# PHILCO SERVICE

## PHILCO RADIO, MODEL 46-1201

### PRODUCTION CHANGES FROM APRIL 1, THROUGH AUGUST 31, 1946

This bulletin contains production changes made since the printing of Philco Service Bulletin PR-1100, and lists differences between codes on Model 46-1201 Radios. These bulletins should be used in conjunction with Philco Service Manual PR-1167.

FIGURE 1. POWER SUPPLY AND AUDIO SECTION USED ONLY IN CODE 122.

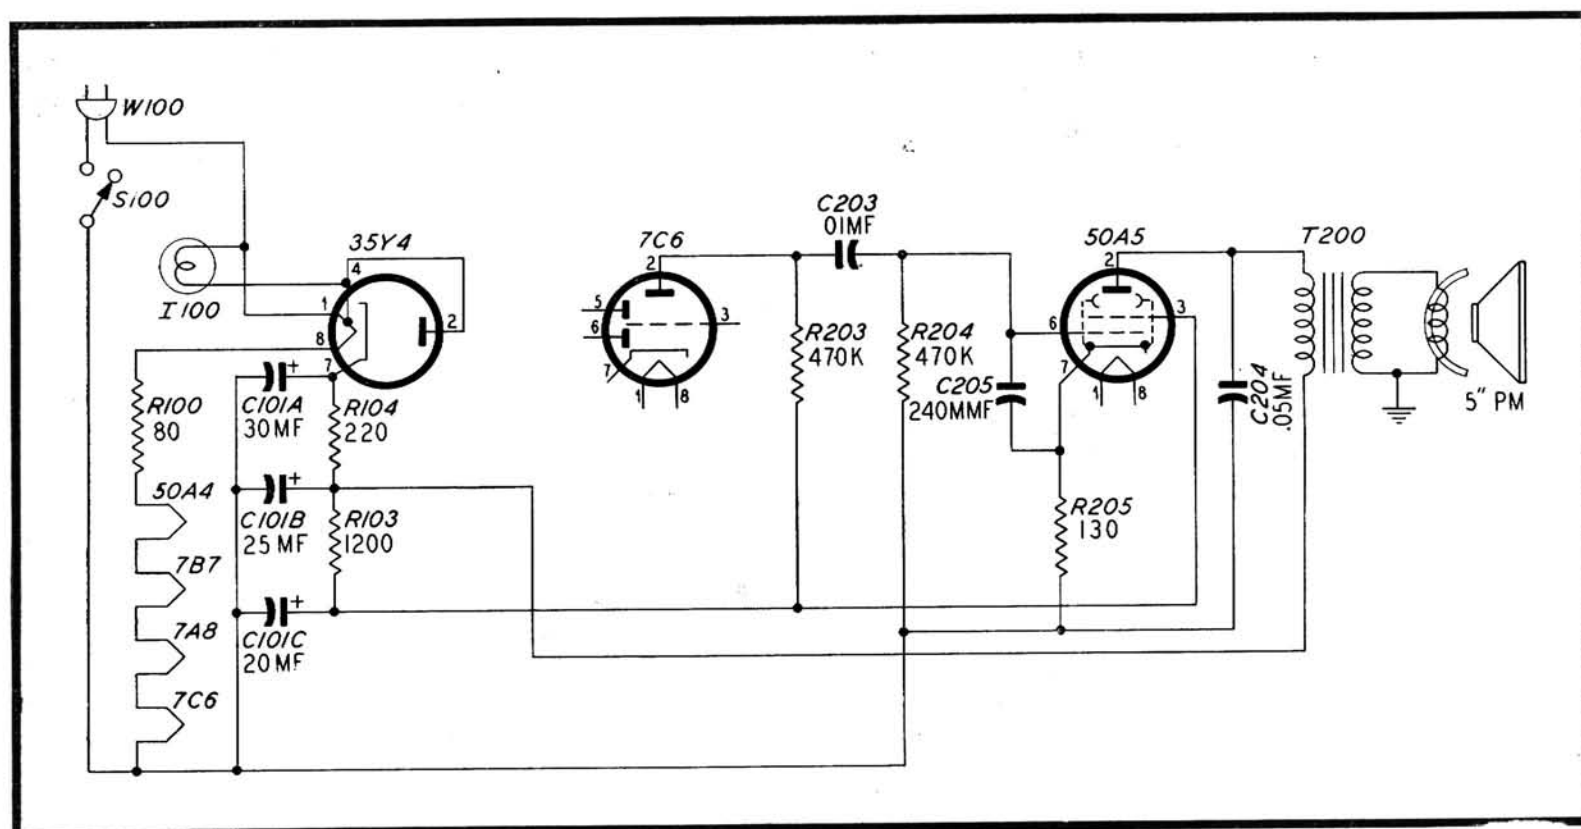
Code 122 of the Model 46-1201 is different from all other 46-1201 codes because the voltage-doubler power-supply circuit was removed and replaced with a conventional half-wave rectifier circuit. The 4" x 6" oval electrodynamic speaker was replaced with a 5" round, permanent-magnet speaker. Because of the removal of the speaker field as a choke, considerable changes were made in the power-supply filter network. Parts changes and schematic (figure 1) applicable to Code 122 are as follows:

1. Tube, rectifier, 50Y6GT/G, was changed to a 35Y4.
2. Tube, audio output, 35L6GT/G, was changed to a 50A5.
3. Condenser, C101, part no. 30-2559; C102, part no. 30-2559; and C104, part no. 30-2548, were replaced by a triple section 30-25-20 mf condenser, C101A, B, C, part no. 30-2573. Part of manual affected: Replacement Parts List and figures 3 and 12.
4. Speaker, electrodynamic, oval, part no. 36-1587\*, was replaced with a round 5" permanent-magnet speaker, part no. 36-1617-2. Part of manual affected: Replacement Parts List and figures 5 and 12.
5. Cable, speaker, 41-3728, was changed to 41-3759. Part of manual affected: Replacement Parts List.
6. Resistor, R100, dual, 80 ohms, 65 ohms, part no. 33-3426, was replaced by single 80-ohm resistor, part no. 33-3425.

7. Resistors, R101 and R102, were removed from power-supply filter circuit. Part of manual affected: Replacement Parts List and figures 3 and 12.
8. Condenser, C103, was removed. Part of manual affected: Replacement Parts List and figures 3 and 12.
9. Condenser, C204, .03 mf, part no. 45-3500-1\*, was changed to a .05 mf, part no. 61-0122\*. Part of manual affected: Replacement Parts List and figures 5 and 12.
10. Resistors, R103, 220 ohms, part no. 66-1224340\*, and R104, 1200 ohms, part no. 66-2123340\*, were added to power-supply filter circuit. Part of manual affected: Replacement Parts List and figures 3 and 12.

FIGURE 2. POWER SUPPLY AND AUDIO SECTION USED IN CODE 127.

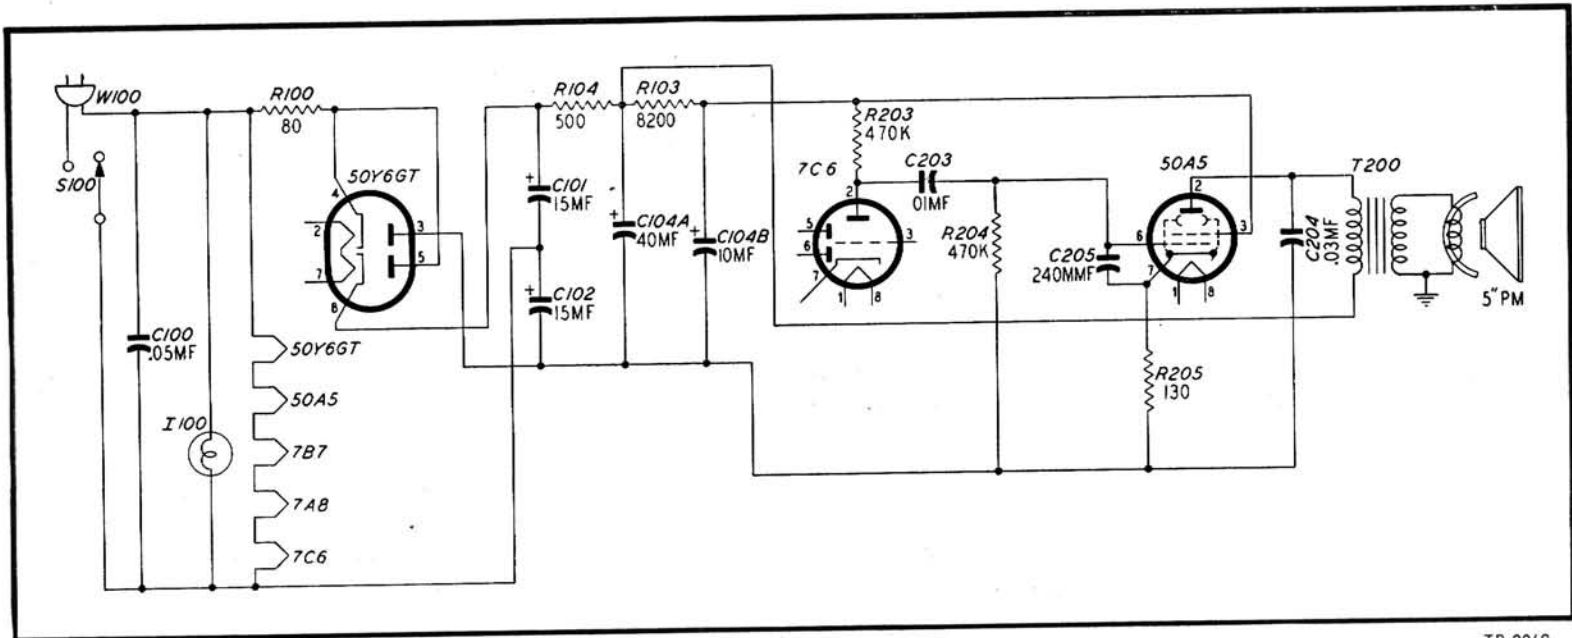
18. Code 127 is similar to Code 121 (as shown in manual) except that it uses a permanent-magnet dynamic speaker and a Loktal type 50A5 output tube in place of a 35L6GT/G. The rectifier filter circuit was changed to use a resistor in place of a filter choke. Parts changes and schematic (figure 2) applicable to Code 127 are as follows:

19. Tube, audio output, 35L6GT/G, was changed to a 50A5.
20. Resistor, R205, 130 ohms, part no. 66-123340\*, was added to cathode of 50A5. Part of manual affected: Replacement Parts List and figures 5 and 12.

21. Resistors, R104, 500 ohms, part no. 33-3435-3, and R103, 8200 ohms, part no. 66-2824340\*, were added to power-supply filter circuit. Part of manual affected: Replacement Parts List and figures 3 and 12.

22. Speaker, electrodynamic, oval, part no. 36-1587\*, was replaced with a round 5" permanent-magnet speaker, part no. 36-1617-2. Part of manual affected: Replacement Parts List and figures 5 and 12.

23. Cabinet, part number changed to 10664B. Part of manual affected: Replacement Parts List.
24. Resistor, R100, dual, 80 ohms, 65 ohms, part no. 33-3426, was replaced by a single 80-ohm resistor, part no. 33-3425.

25. Resistors, R101 and R102, were removed from power-supply filter circuit. Part of manual affected: Replacement Parts List and figures 3 and 12.
26. Condenser, C103, was removed. Part of manual affected: Replacement Parts List and figures 3 and 12.

27. Condenser, C104, 40 mf, electrolytic, single section, was replaced by a dual section 40-10 mf, 200-volt condenser, part no. 30-2554. Part of manual affected: Replacement Parts List.

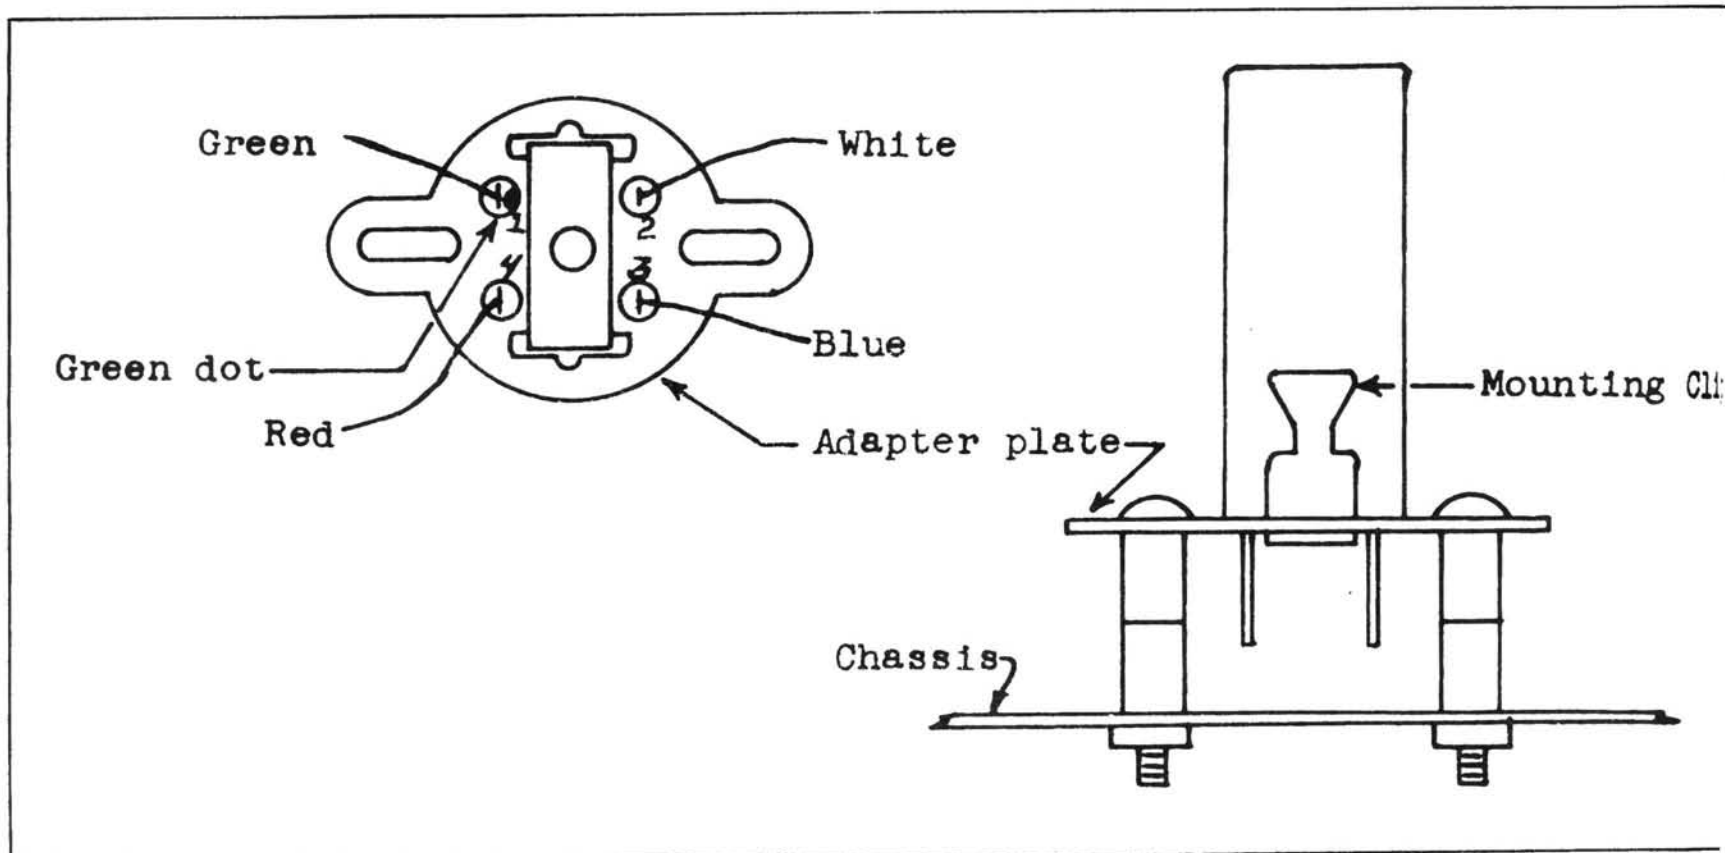
The majority of these cases have been traced to a change in tuning of the second i-f transformer, Z301, Part No. 32-4005. This transformer, because of its location close to the output tube, becomes overheated under certain operating conditions, causing wax to flow from the coil or coil form into the trimmer-condenser plates. Therefore, detuning of the stage and loss of sensitivity and selectivity result.

Since the trimmer plates become stuck together, retuning of the stage is often difficult, and even if accomplished, subsequent heating and cooling may again result in detuning. A permanent repair may be made by replacing the faulty transformer with one of the permeability-tuned type. A kit, Part No. AD-1024, includes this transformer and mounting hardware.

1. Remove the two nuts used to mount the original coil, 32-4005.
2. Force one end of the brass coil-retaining clip upward and inward, to permit the coil shield can to be removed.
3. Cut the red, blue, white, and green leads, leaving one inch in length above the chassis, and strip one-half inch. Cut the black lead off close to its terminal under the chassis, as this lead is not used.

4. Drill a 3/16-inch hole halfway between, and in line with, the two holes in which the transformer was mounted; this provides an access hole for the transformer primary adjustment. Some codes have a hole that may be used for this purpose by mounting the replacement transformer at a suitable angle to use holes available.
5. Set the new transformer in place, with terminals 1 and 2 adjacent to the rectifier tube, and make the connections as shown in the bottom-view drawing.

6. Install the transformer in the mounting holes for the original transformer, by means of the adapter plate and hardware provided, as shown in the side-view drawing.

7. Follow the alignment instructions given in the service manual, with the exception that, for this transformer, which is inductively tuned, the secondary adjustment is made through a hole in the top of the shield can, and the primary adjustment is made through a hole in the bottom.

8. When tuning this transformer, use a fibre tuning stick, as the iron core is not at ground potential; also, the core may be damaged by using a metal screwdriver. The fibre screwdriver should be 1/8" in diameter, with the point ground down to a 1/16" wedge.

9. If any tendency toward oscillation is noticed, connect a 100 mmf. condenser, Part No. 60-10105407, between terminals 2 and 4 of the transformer, and realign.
